Discussion Item

**Landscaping Approach to 1631
Ripon Place**

BLDG 843

1631 RIPON PLACE
PARTIAL LANDSCAPE PLAN REAR TERRACE
1"=10' MARCH 2020

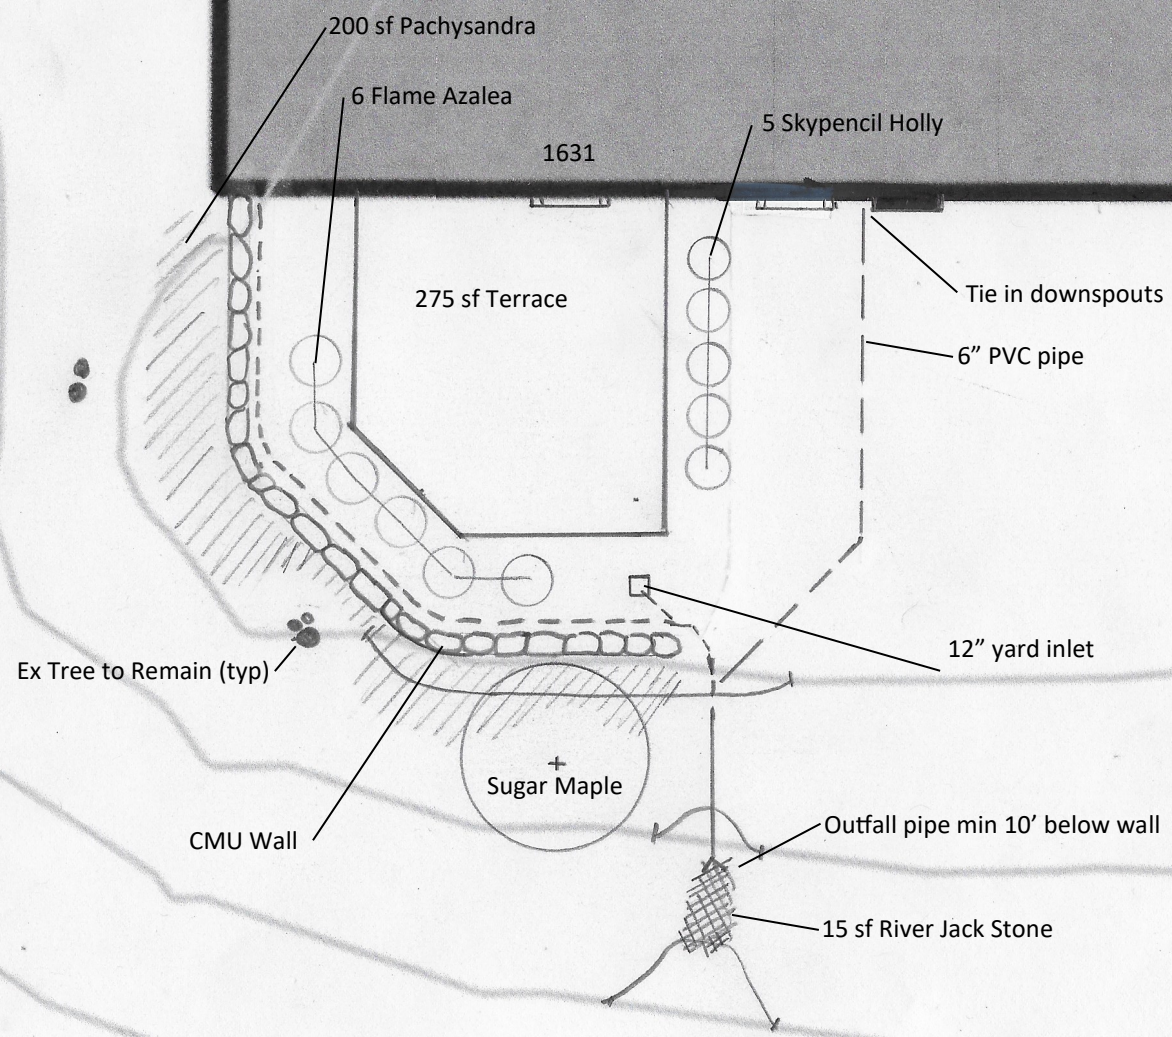
Our assessment is similar to that of the landscape architects. The resident's patio appears to have settled and the stone retaining wall appears to have moved as well. However, the building distress did not appear to be significant enough to warrant geotechnical involvement. We observed settlement cracks at the back-right corner of the building which may or may not be related to the slope. The corner wall appeared to be planar so we do not have cause for immediate concerns related to the building structure. We recommend repointing the cracks at the back corner and monitor for re-cracking.

One important thing to note is, if you are planning to cut into the slope at the side/rear of the building, we definitely recommend getting Gerry involved. Based on our recent experience with 525 and 527, it may not be advisable to cut into the slope with retaining walls. We weren't aware of the soaker hose – is this being actively run, or has it been removed?

- It is good to plant low-height bushes at the top of the slope as these are light-weight and reinforce the soil.
- It is good to plant trees in the lower third of the slope as these reinforce the soil. They are heavy though and should only be installed near the bottom of the slope.
- It is bad to overwater plants on the slope as this adds weight to the slope.
- The trench drain that was previously installed at the back of Building 833 should not make the slope creep worse as less water means less weight on the slope.
- Installing retaining walls cuts out grade, which reduces weight at the bottom of the slope. This makes the slope more susceptible to creep.

- Lower the patio and install stairs to step down from the rear door to the patio. This will reduce weight at the top of the slope, which will slow the slope creep but may not entirely eliminate it.

Minimum frost depth above the building footing is required to be maintained if this option is pursued.

- Install helical piers and framing to support the patio. This alternative is costly, and the helical piers would be subject to bend over time.
- Install geogrid and stone to reinforce the slope (also costly).

The best option is probably to follow the guidelines related to plants, etc. above and for the resident to consider lowering her patio during replacement if that is something that Parkfairfax allows. These notes are based off of Gerry's input – let either of us know if you have questions.

Important notes regarding cutting into the slope. If you recall when you and I were walking around, I suggested that we re- do a retaining wall but essentially build it in front of where the failing ledge stone wall is. The idea of the wall re-do would be to stabilize the area where the patio is and to promote drainage where we want it to go. It would seem that much of the ground plain at that corner of that building is fill anyhow. Doing a wall such as we propose would mean removing the lower quality trees and most of the shrubs in the immediate work area, but we should be able to work around anything of consequence. That is what I am laying out.

We discovered a soaker hose on the top of the patio in the dirt area directly above the stack stone. The influx of water may have contributed to the soil behind the stone washing away causing some of the slump or creep.....the opposite end of the building has the same wall construction although the elevation is different it has no noted issues.

Based on the input, per Gerry we should be very hesitant on installing a full lower wall. We have passed this onto Jeff who will be providing us with a design taking this into consideration.
